AL/CF-TR-1994-0056

**A HUMAN FACTORS EVALUATION OF
THE MH-60G PAVE HAWK HELICOPTER COCKPIT (U)**

JANUARY 1994

Figure 18. Mean Display Factor Rating for the Fuel Management panel.

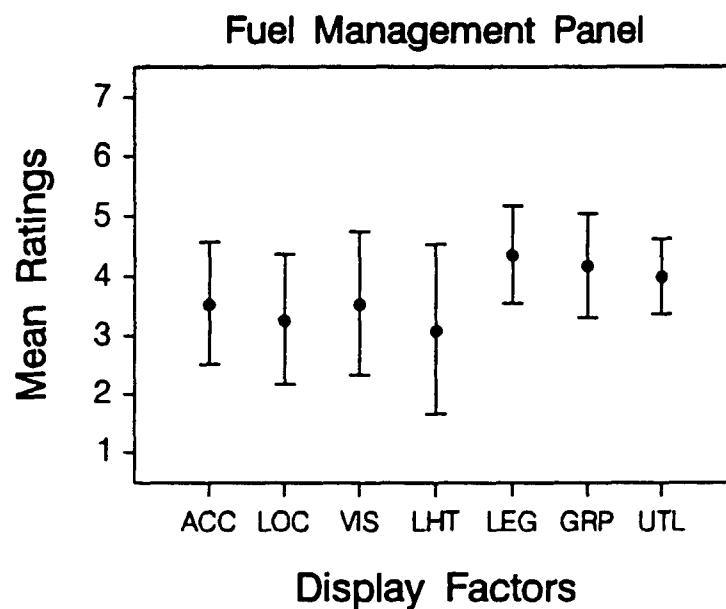
Again, one of the major complaints was the bad lighting for night operations. The controls need to be backlit. The location of the panel on the aft console was considered poor also. There were complaints that 1) during aerial refueling, the operator had to take his eyes off the tanker to monitor the fuel overflow light/indicator, 2) the pilots can't read the switches because they are upside-down and 3) the panel location makes it easy to forget to stop a fuel transfer after one has been started (one pilot said "it happens all the time"). All of these problems are unacceptable. Flying at night, in formation, performing aerial refueling demands that the pilot be able to keep his eyes "outside" the cockpit at all times. Taking them "inside" to monitor the overflow indicator or to decipher the upside down switch labels is dangerous and threatens not only the success of the mission but also reduces flight safety. The panel should be NVG compatible. The panel should be more accessible. The panel switch labels should be oriented properly so that crew members do not have to mentally rotate them to read them.

Figure 20. Reconfigured Lower Console with Radios Integrated into the CDU.

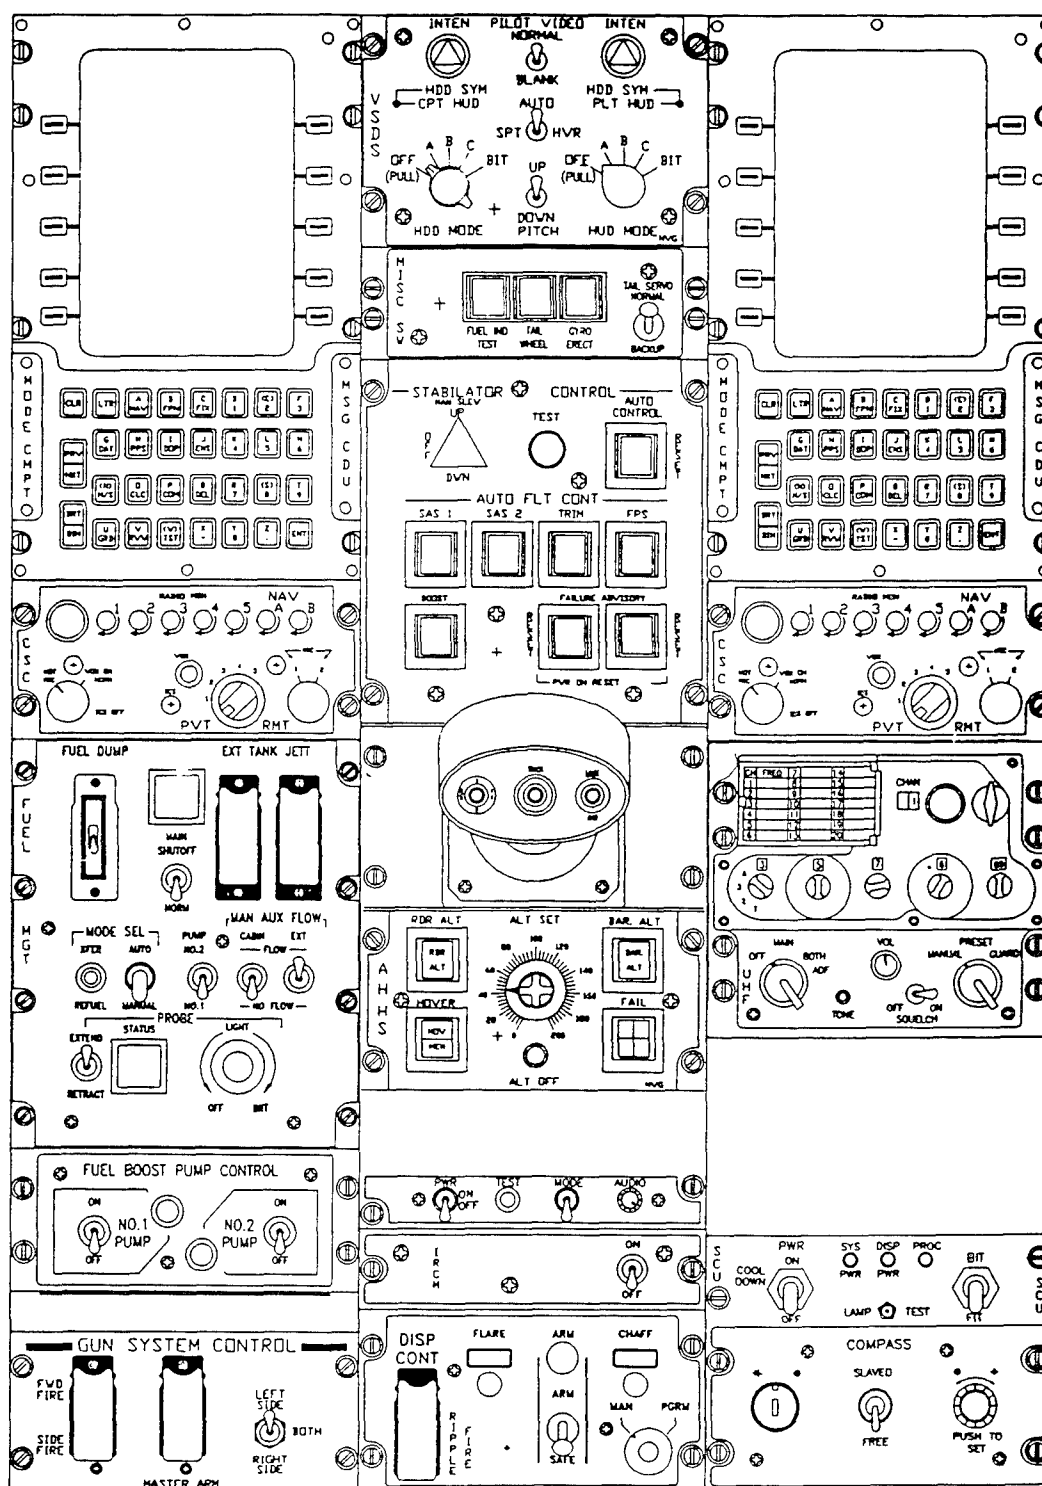
The obvious solution to the problem is to integrate the radios with the CMS-80 and access them through the CDU. Another solution which is in place in the Army MH-47E is to integrate the communications and have a control on the cyclic to select radios with a small display located on the forward console to indicate the selected radio. Integrating the communication systems would not only alleviate the problems associated with radio access, but also free up considerable space on the center and aft consoles. Reconfigured lower and aft consoles with the radios integrated into the CDU are shown in Figures 20 & 21. This reconfiguration would drastically reduce the size of the aft console. The reconfigured aft console would also provide an alternate egress route for pilots and give the flight engineer visual access to controls and displays in the cockpit.
